# Historic Preservation Design Review

## HP-14-03, 41 W. Liberty St. (City)

**Request:** Design review approval for proposed façade restoration/renovations to include: new windows, doors; and repainting to match prior and return to original design.

**6627 PINE IG**

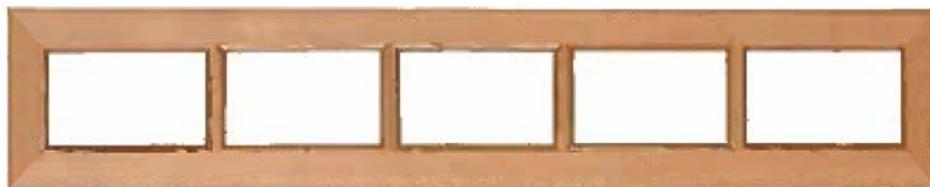
1. Replace the front door with #6627 Pine IG from Dealers Supply and Lumber Co. to be installed as double doors:

(Note: the applicant has requested approval to use snap-in plastic sashes in the transoms and doors, but did not include a photo of the product. The photos included in this report are what the applicant initially proposed for use, and staff recommends the use of the higher quality wooden sash doors and transom.)

1. Replace the front door with #6627 Pine IG from Dealers Supply and Lumber Co. to be installed as double doors with snap-in wooden mullions on inside of doors;
2. Install a transom above the double doors (#6705 Transom) from Dealers Supply and Lumber Co.;
3. Repaint the doors 'Golden Oak' stain;
4. Replace windows with new plate glass, wooden trim around windows to be painted 'Coventry Gray' HC169 ;
5. Repaint the rear of the building to match existing color – Benjamin Moore 'Baby Turtle' 2B 515;
6. Same wooden door to be placed in rear, and stained same as front;
7. Shutters replaced and painted to match existing;
8. Blue fabric awning placed on rear of building to match awning in front.
9. Lighting to be added underneath awning, will not be visible.

**6705 Transom**

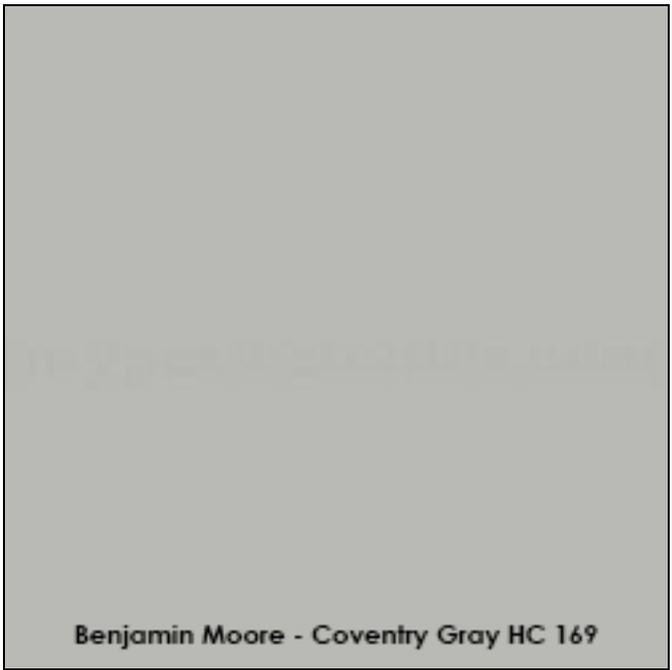
2. Add a transom above the double doors (#6705 Transom) from Dealers Supply and Lumber Co.:

- a. Original transoms should be preserved and maintained.
  - b. Transoms should not be enclosed or obscured with new materials.
  - c. Historic transom materials such as prism glass or leaded glass should be preserved and maintained.
- The style of the original windows, doors and transoms is unknown, however the replacement style chosen is in keeping with the look of the downtown and meets the design criteria. The windows to be replaced are aluminum and are not original to the building.
